MIDLAND UNITS 1 & 2  
JOB NO. 7220

REVIEW OF U.S. TESTING  
FIELD AND LABORATORY CONSTRUCTION  
TEST DATA ON SOILS USED AS FILL

BECHTEL ASSOCIATES PROFESSIONAL CORPORATION  
July 1979

FIGURE 1

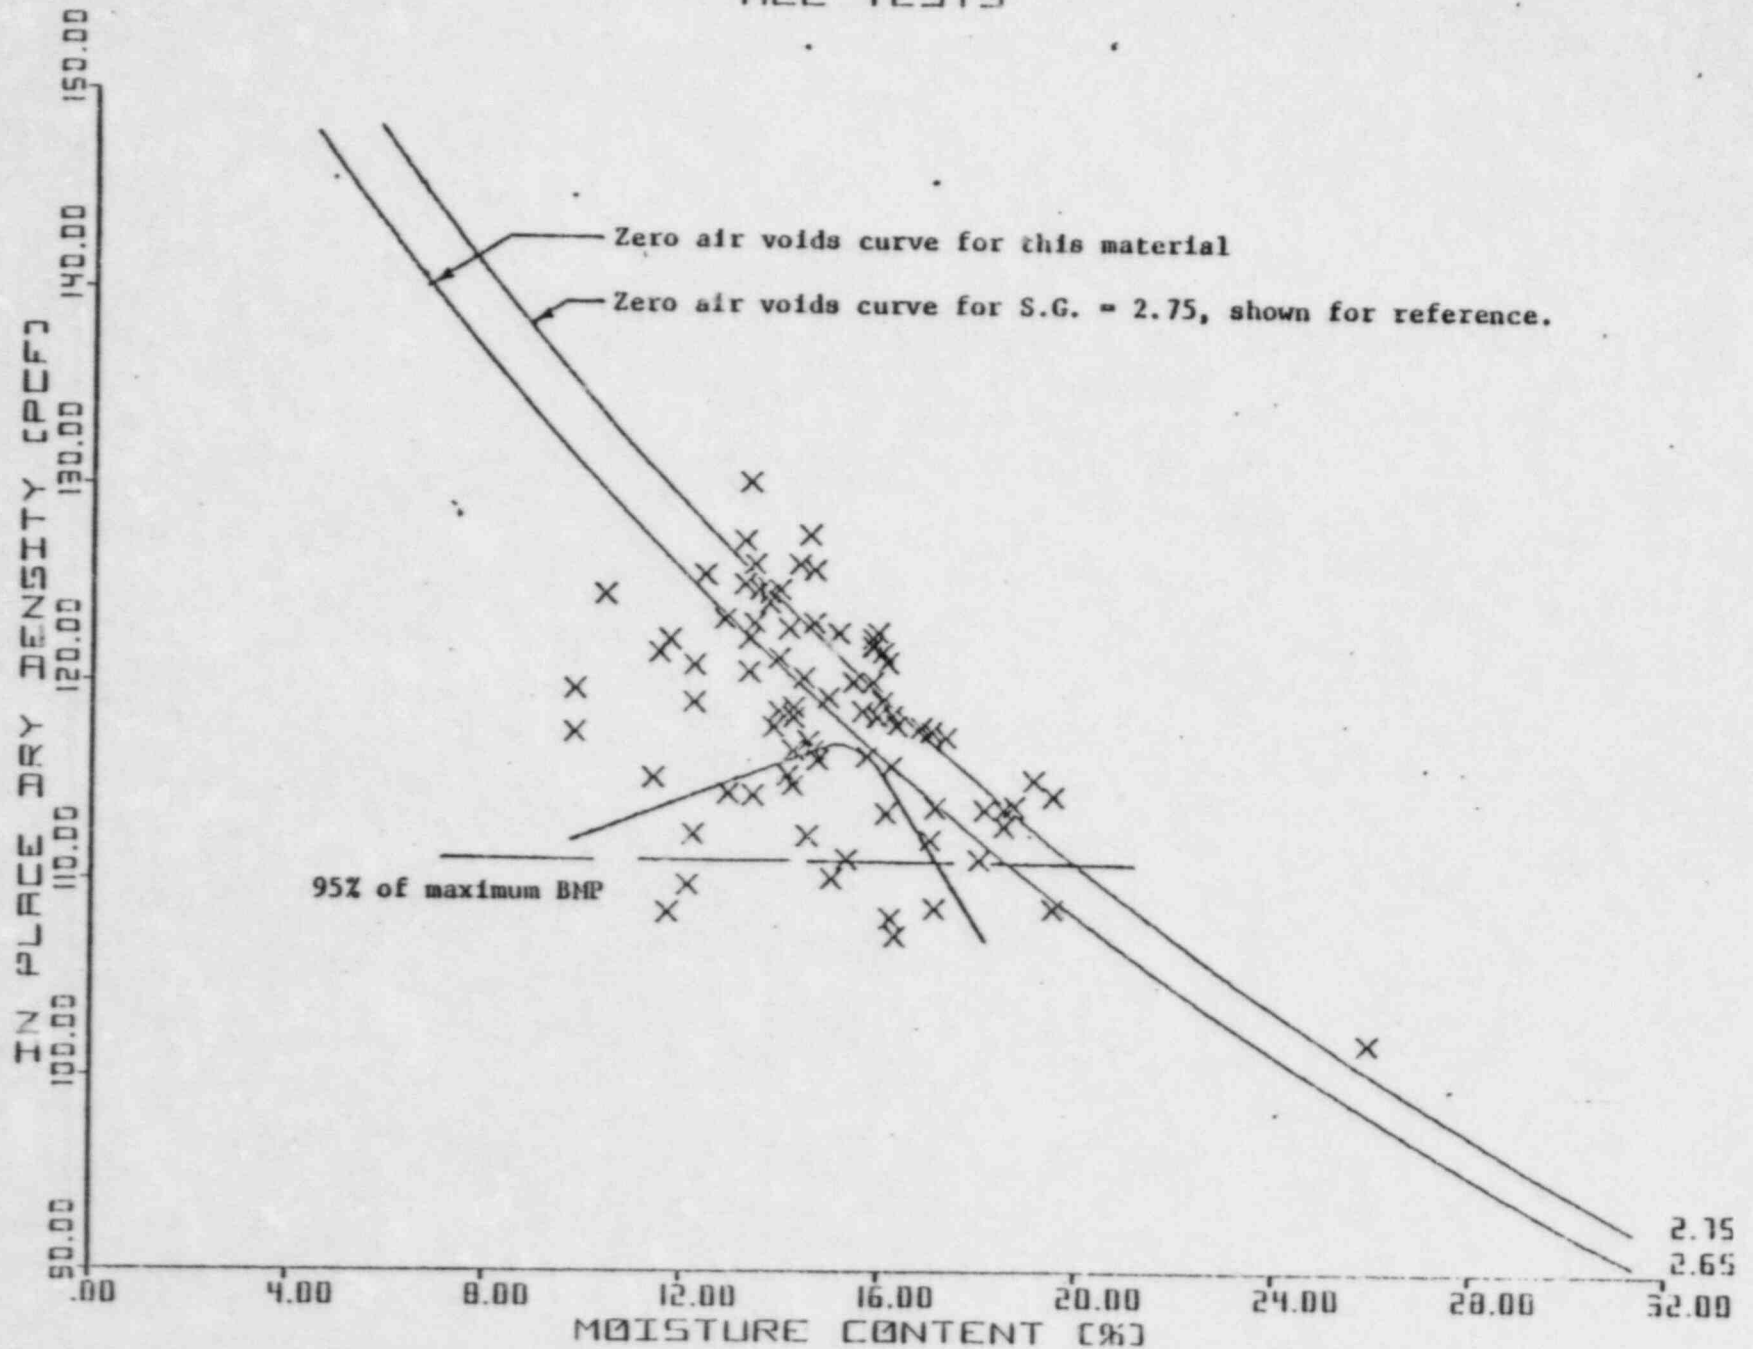
Item 3 on Page 2 states in part, "Figure 1 attached shows a typical laboratory compaction test curve with field test results plotted on it" Is this a typical laboratory compaction test with respect to the number of tests plotted to the right of the zero air voids curve or just a typical plot of a compaction curve?

FIGURE 2

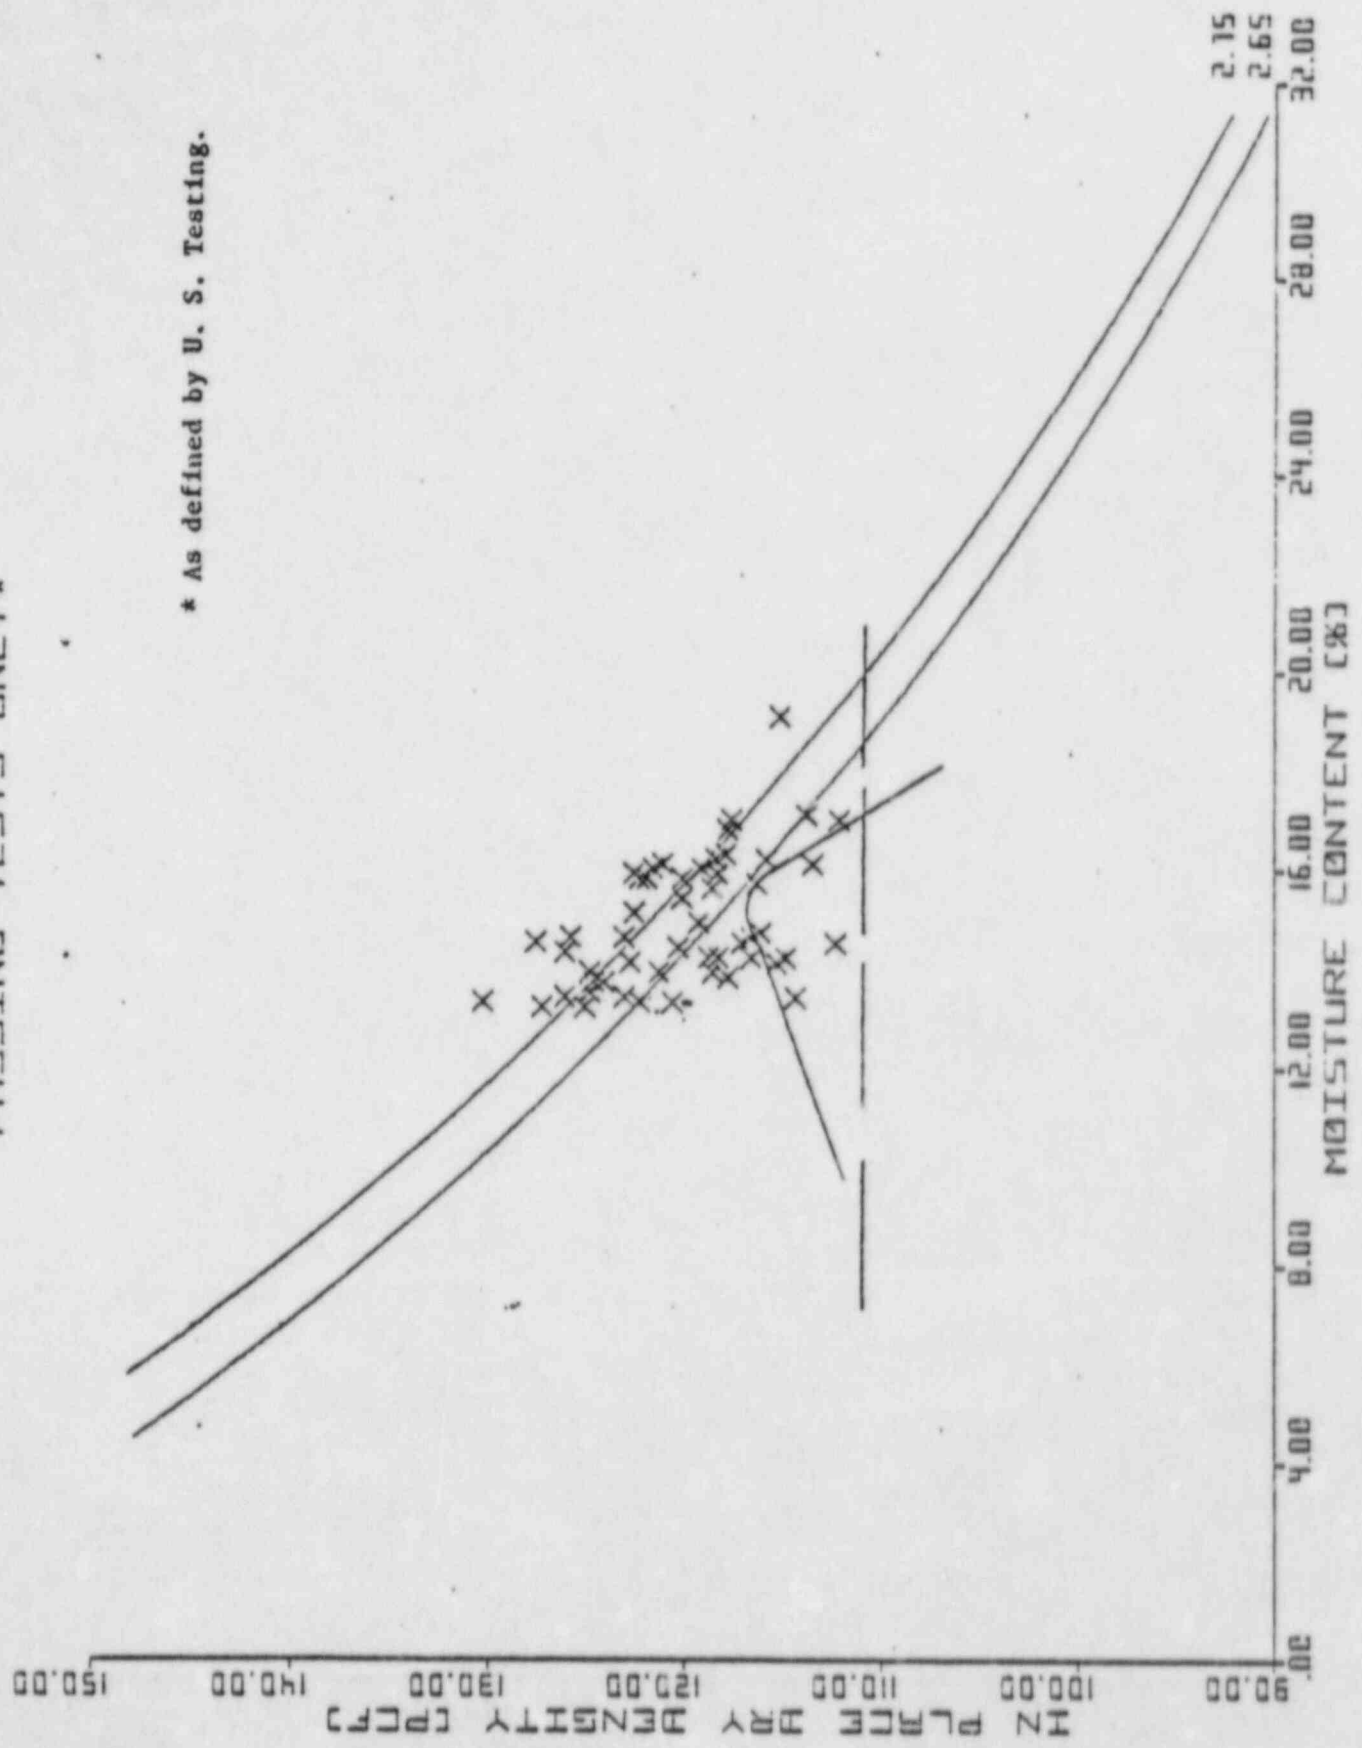
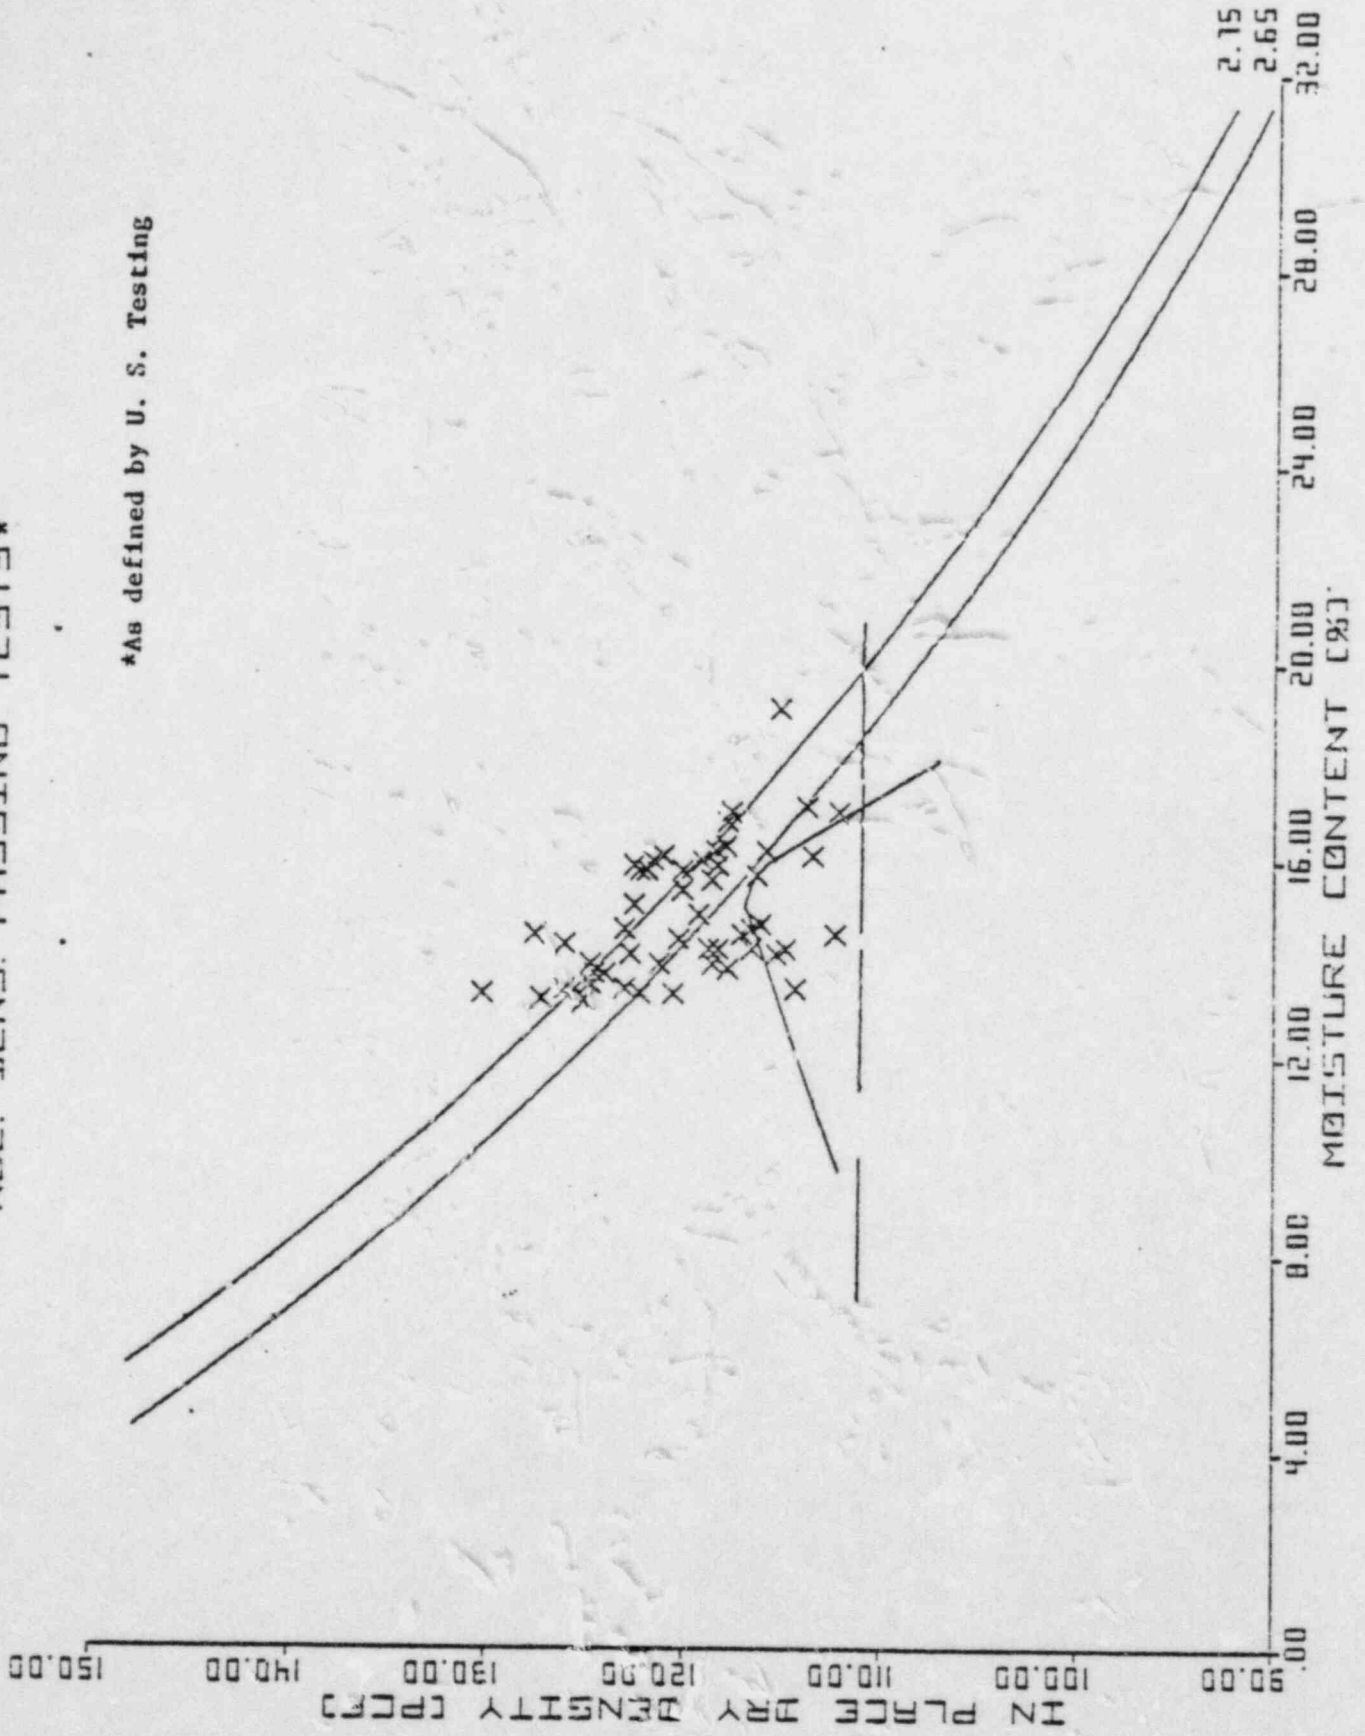
Figure 2 and 5 -- there are approximately four tests that are shown to the right of the ~~water~~<sup>optimum</sup> moisture content plus 2% line which should be failing tests but are shown as passing tests.

FIGURE 7: WINDOWS OF ACCEPTABILITY (A) BASED ON BMP SPECIFICATION (B) REGARDLESS OF EXACT WORDING OF SPECIFICATION

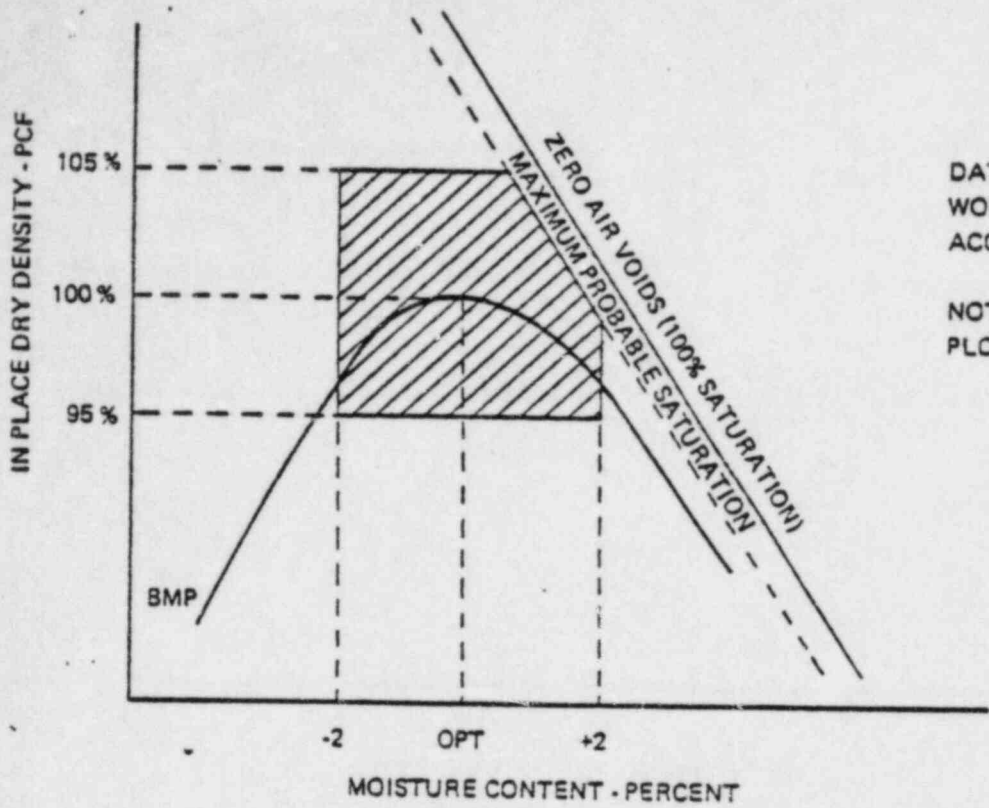
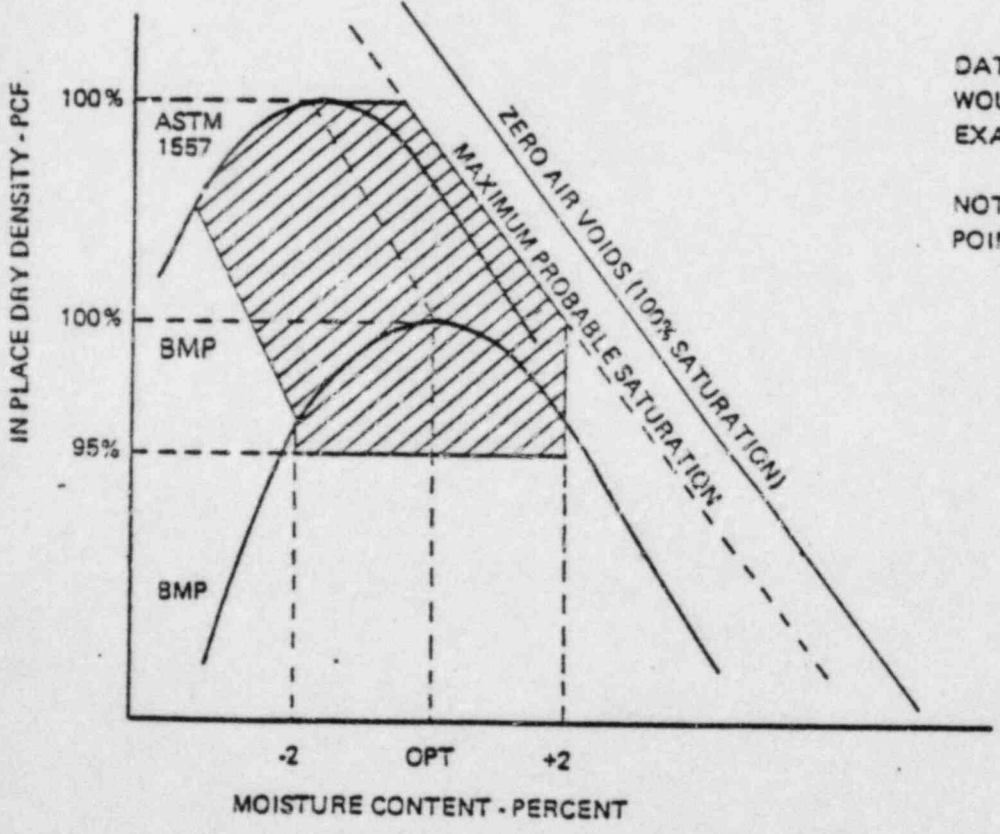
Page 4, Third Paragraph and Fourth Paragraph reference Figure 7a. This should be Figure 7A.

Page 4, Last Paragraph states in part, "Figure 7B was arrived at by expanding Figure 7A to include test results up to a compactive effort related to ASTM D15.57 (56,255 ft-lbs/cu ft) which is considered to be a practical upper limit." I don't feel that this is a practical limit based on lift thicknesses and compaction equipment. Bechtel modified proctor is more applicable than practical.

FIGURE 9

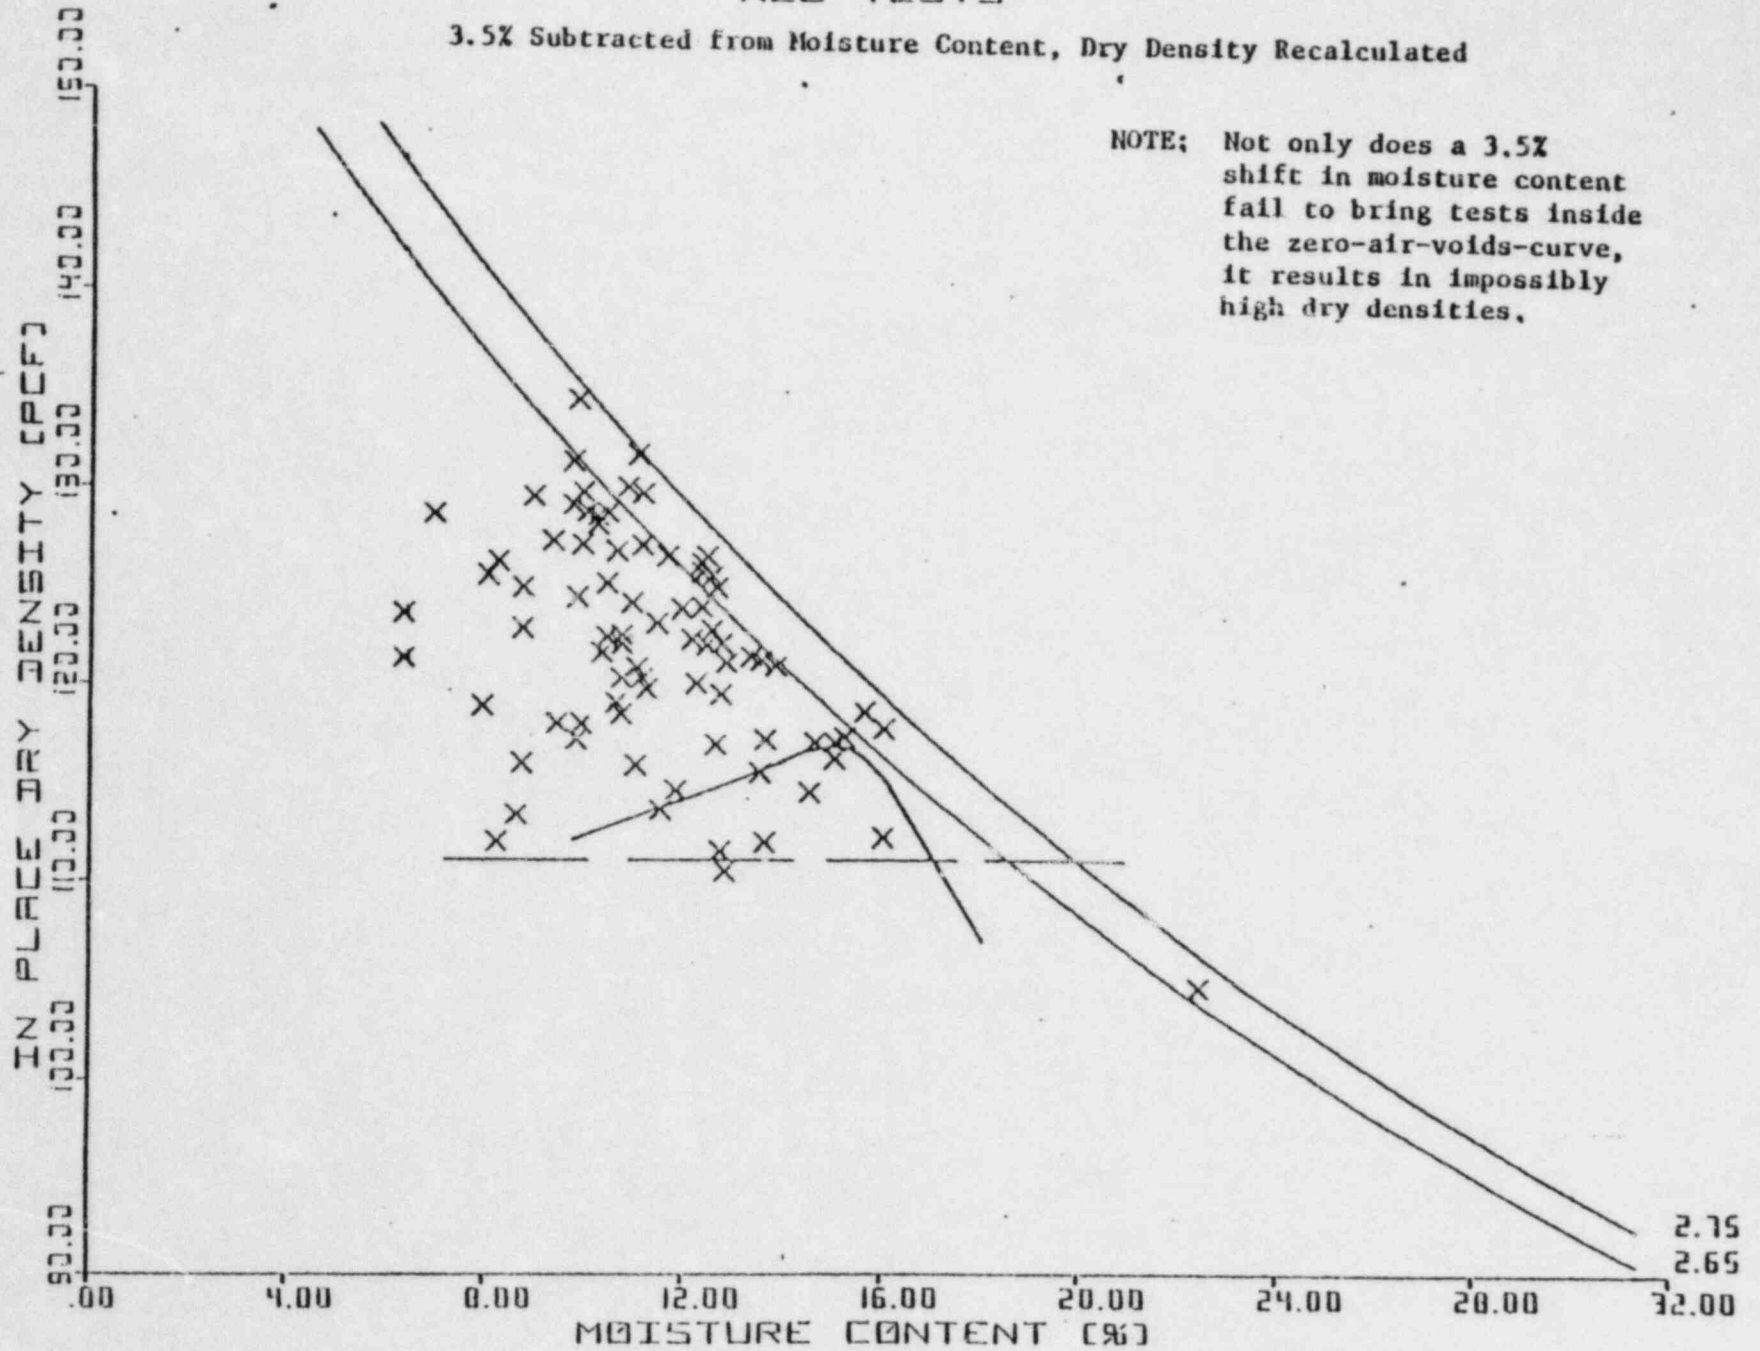
Figure 9 has subtracted 3.5% from the moisture content and recalculated dry density. Couldn't the nuclear densometer also be giving incorrect wet densities?
